Millennium Mine

It is advised that MetRes Pty Ltd has lodged an application for a major amendment to an environmental authority in accordance with the requirements of the *Environmental Protection Act 1994*. The environmental authority being amended is EPML00819213.

The submission package under assessment is the proponents response to an information request (IR) received by the administering authority on 15 August 2024.

**Millennium Coal Mine EPML00819213
Environmental Authority amendment
Information Request Response**

Figure 1. New Chum Creek and Isaac River catchments

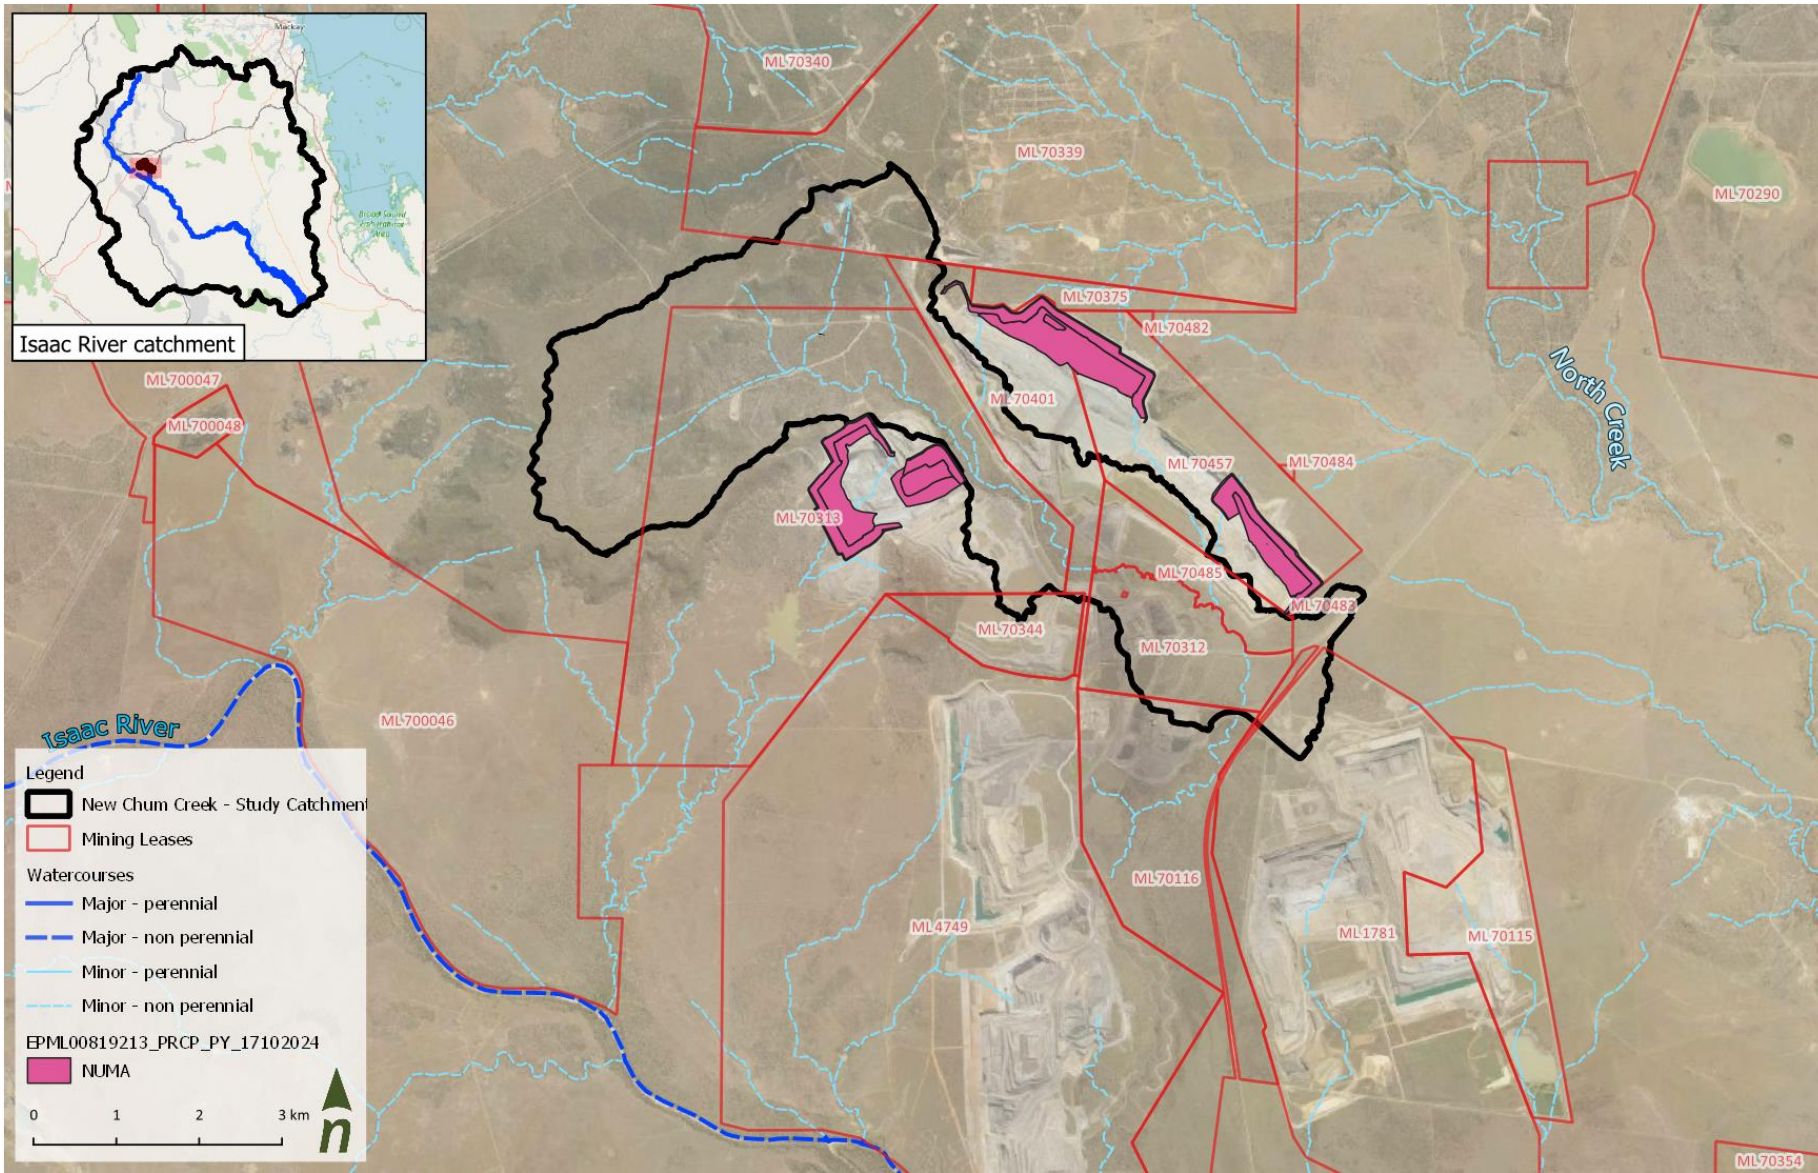
<p>NUMA supporting information</p> <p>Section 5.3 Surface water</p>	<p>NUMA within the catchment to clarify proximity of the proposed NUMA's to the Isaac River/New chum creek which flows through the site.</p> <p>Additionally, the section does not discuss the potential impacts of flood situations, interaction of the flood waters with the residual void waterbodies containing saline waters considering the proximity of the MCM to the New Chum Creek.</p> <p>The EP Act section 226A(f) requires the EA amendment application to include assessment of likely impacts of the proposed amendment on environmental values including description of risk, likely magnitude and management practices to prevent or minimise adverse impacts.</p>	<p>a) Isaac River and New Chum Creek catchment area details.</p>	<p>a The New Chum Creek catchment area with proximity to the NUMA is presented in Attachment E Error! Reference source not found. The catchment assessed is 22.8 km².</p> <p>Based on the PRCP landform, the catchment area of New Chum Creek is anticipated to change by 0.075km² which accounts for 0.3% of the study area and not anticipated to result in any material changes to peak flows or runoff volumes.</p> <p>Sub-catchments have been delineated to provide for appropriate representation of the routing behaviour in the study area. The sub-catchment delineation also aimed to maintain a reasonable ratio (less than 2:1 in general) between catchment length and width ensuring valid catchment routing. Efforts were made to maintain as much consistency as possible in the size of sub-catchments.</p> <p>The initial sub-catchments were delineated primarily based on topographical</p>

The New Chum Creek catchment area with proximity to the NUMA is presented in Figure 1 below. The catchment assessed is 22.8 km².

The Isaac River is the receiving waterway for New Chum Creek however it does not hydraulically impact the subject site and was not considered in this scope of work. The location of the New Chum Creek catchment within the Isaac Creek catchment is shown in the below figure. Detailed discussion of the catchment delineation is provided in **Attachment A** - Section 3.2.

Figure 2 Updated cross-section through Pit A&B and Pit M&D

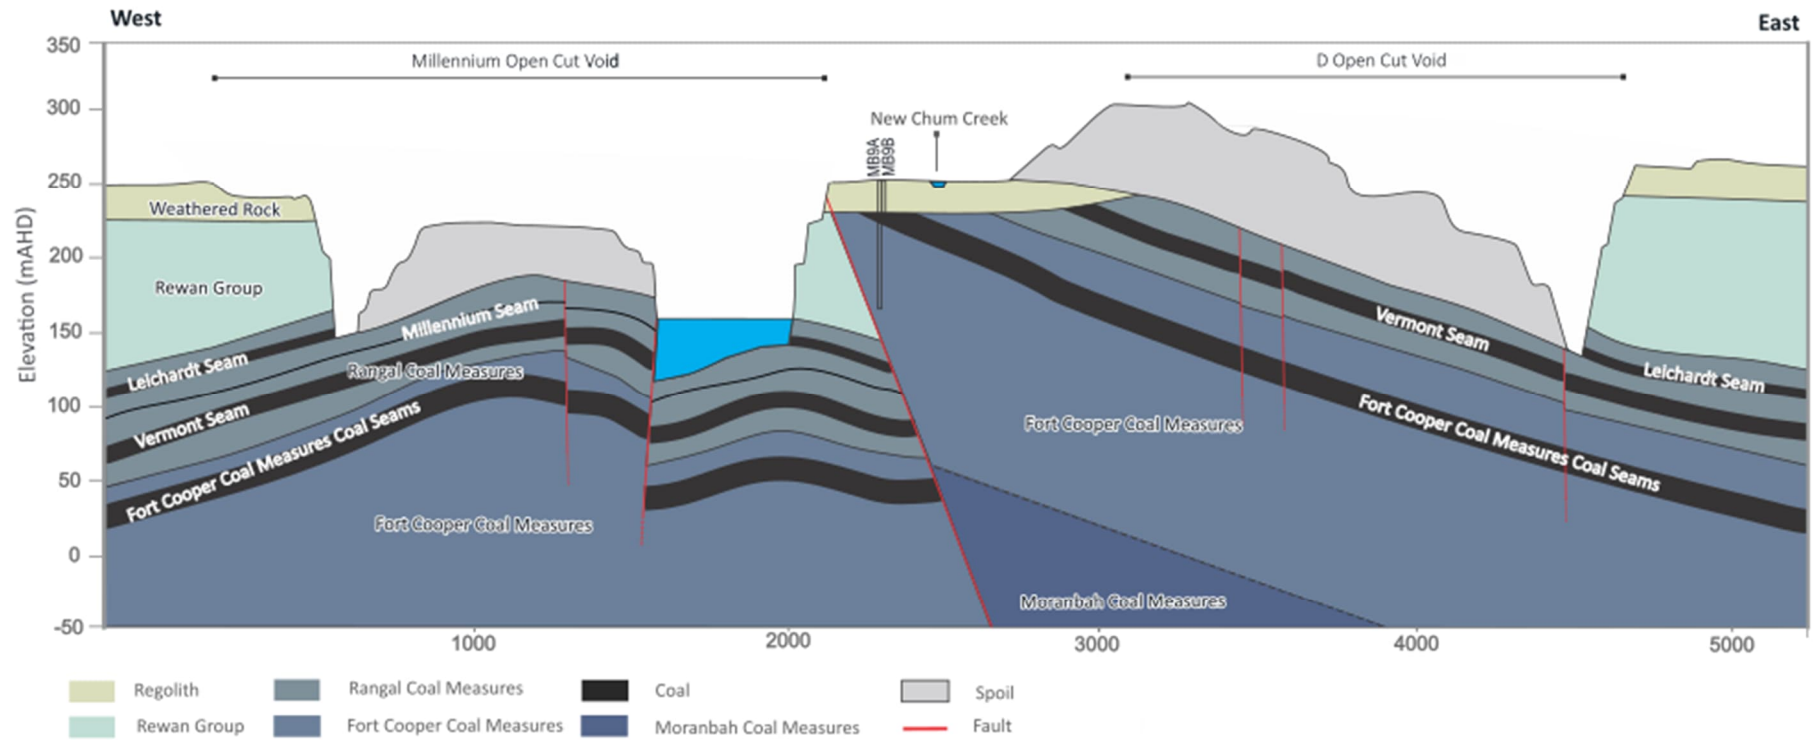
However, Appendix G Figure 3-4 is a cross section showing the locations of Pit A&B and Pit M&D. Pit E is not shown but section 3.2.5 states that: For Pit E the cross section and characteristics are the same as what is observed for Pit M&D.

The Figure 3-4 cross section indicates that the Vermont seam is in the Fort Cooper Coal Measures and that only the Leichardt seam is mined.

The cross section has been updated to reflect the correct nomenclature for the coal seams. The updated cross section is provided in **Figure 2**. An additional cross-section showing Pit E and the Mavis underground mine is provided in **Figure 3**. The Millennium Seam is only present in the Millennium pit south-west of the fault. Leichardt forms the target seam in the open cut-voids and future underground mining. The Vermont Seam is not being mined.

The conceptualisation text, as reproduced in the explanatory text (above) is correct, and the amended cross-sections now represent this description.

Figure 3 Cross section through Pit E and Mavis underground

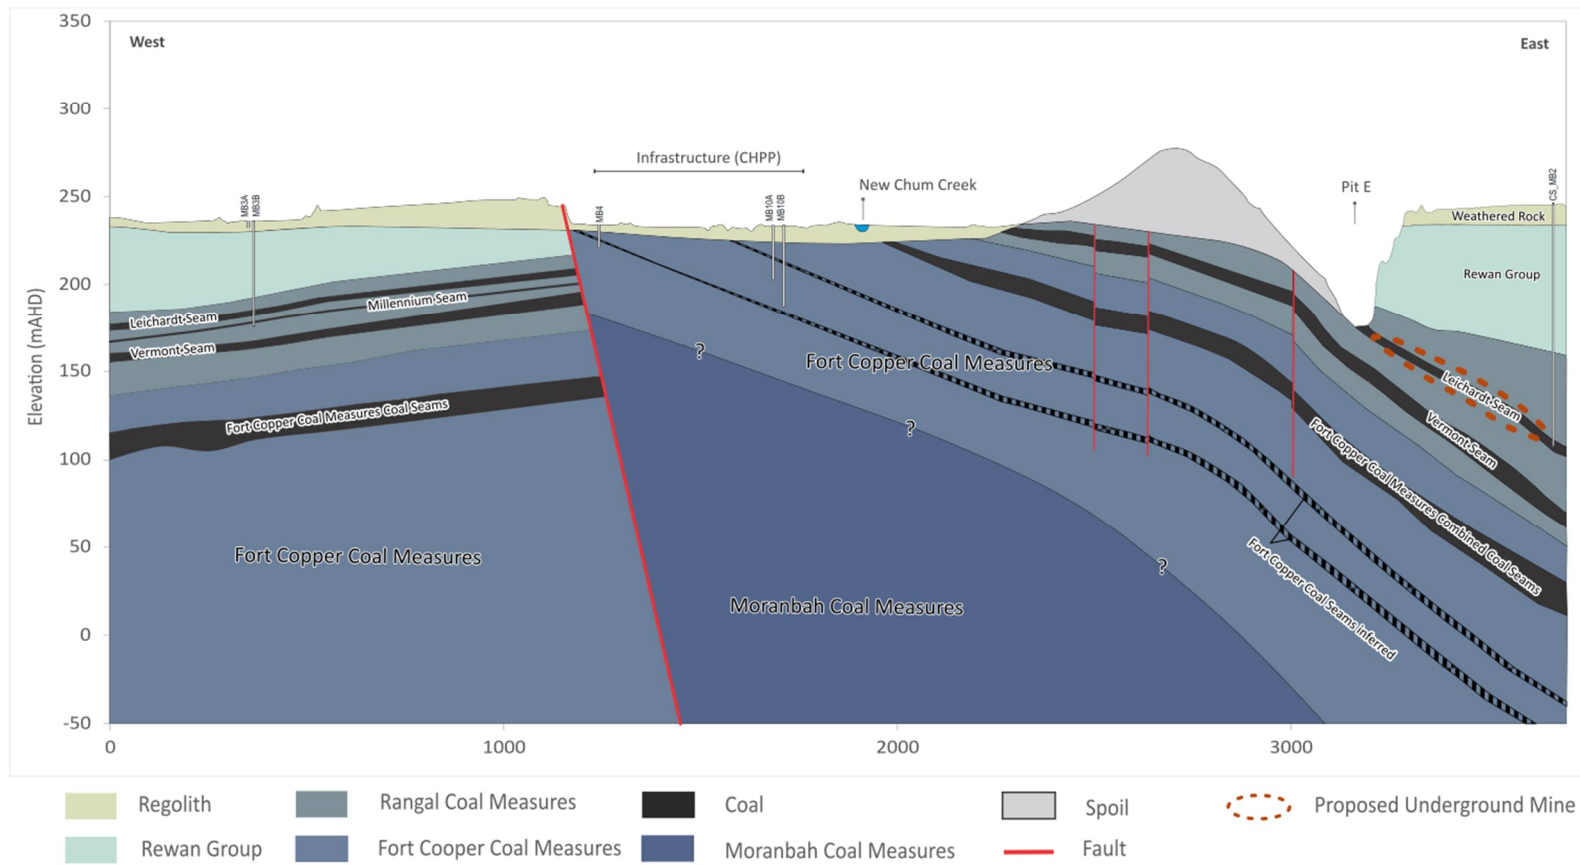
Additionally, it is noted on Figure 4-8 that there is similarity between the groundwater levels in MB3B and MB4. MB4 is identified in Table 4-2 as a Tertiary Sandstone bore screened between 29m and 35m.

- a) A review of the monitoring network, including screened interval, has been undertaken. The three bores in question (MB3A, MB3B and MB4) are presented on the cross-section provided in **Figure 3**. The logs and cross-sectional interpretation both indicate that MB3A is screening the regolith and both MB3B and MB4B are screening the overburden of the Fort Cooper Coal Measures. The logs for MB3A, MB3B and MB4B are provided in **Appendix A**.
- b) The aquifer reference for these bores has been updated in relevant databased and will be included as such going forward.
- c) The inclusion of MB3B and MB4B into the Tertiary Sandstone, rather than the Fort Cooper Coal Measures at the time of initial modelling was not deterministic to the overall model outcomes. The Tertiary Sandstone is proximal to Millenium Mine as isolated deposits occurring along New Chum Creek.

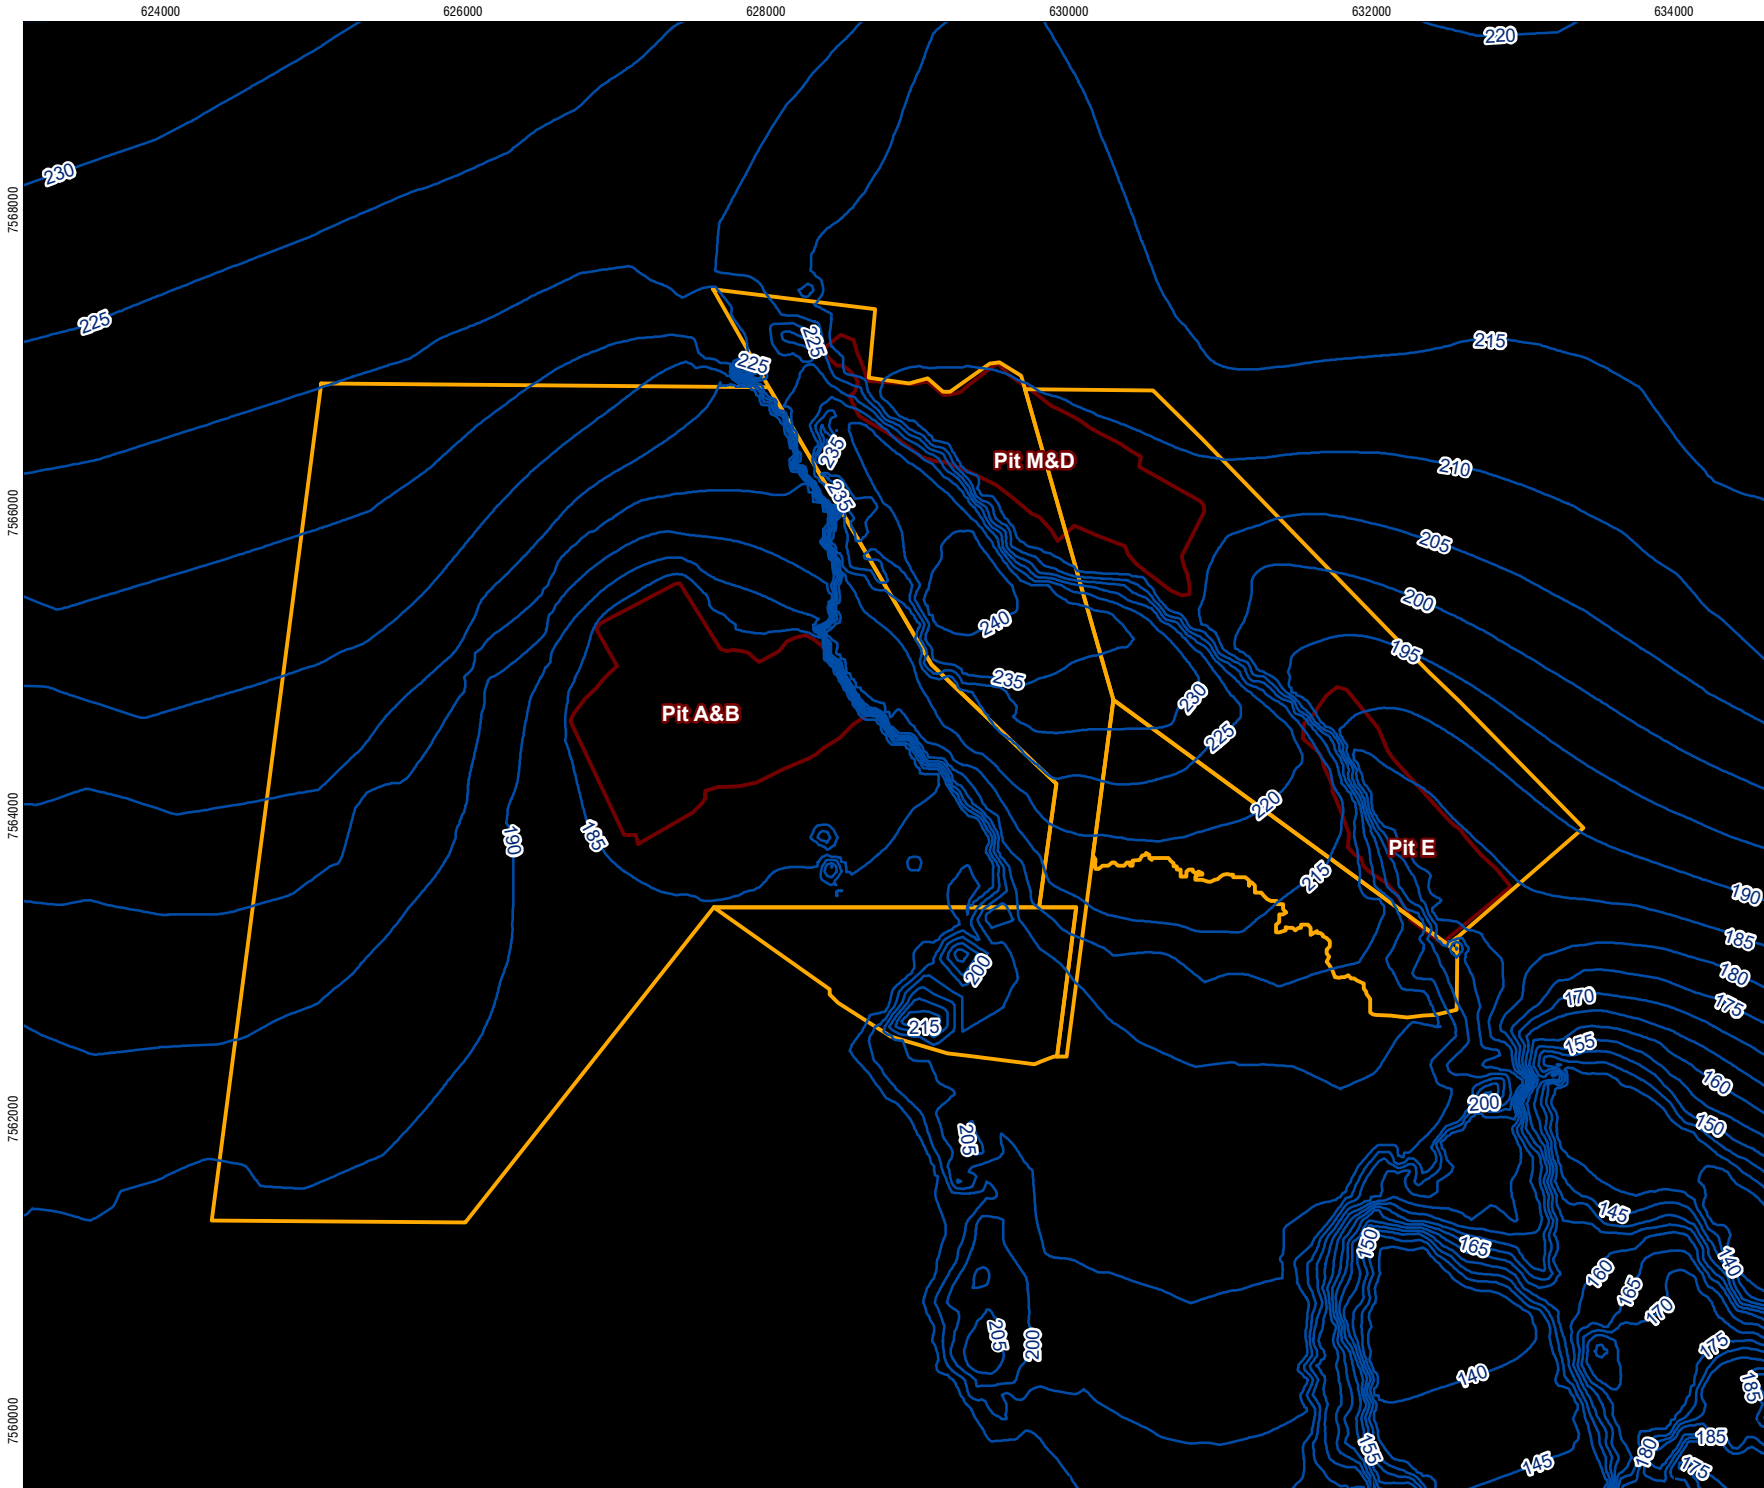
The sink behaviour of all three voids is clearly demonstrated in Figure 6-14 as the capture of water particles in the mining-affected layers in the voids is evident in the results of the modPATH3DU particle tracking simulation. It should be noted that the particles placed along the southern edge of the E-pit area and underground mine extension that leave the Millennium/Mavis Open-Cut area are drawn towards the Daunia mine Titan voids which are also groundwater sinks in the current model set-up. The particle on the western edge of the waste rock dump which leaves the Millennium area and migrates south along the edge of the Poitrel mine area remains within the Rewan group, as its final location is within model layer 3 (Rewan Triassic unit). It is also anticipated that if the Poitrel closure plan were completely implemented in the model with CHDs assigned based on a surface water model, the Poitrel voids should act as sinks and potentially trap this particle as was observed with the Daunia voids to the east.

Figure 6-13 of the PRCP Appendix G was replicated here as **Figure 10**. Instead of showing the particle's layer as they move along the path line, the path lines were coloured per their fate. The aqua colour relates to particles captured by a final void. The pink colour relates to particles that represent regional groundwater flow or particles that are still travelling by the end of the model run (i.e. slow-moving particles that have not yet reached the void as their final destination).
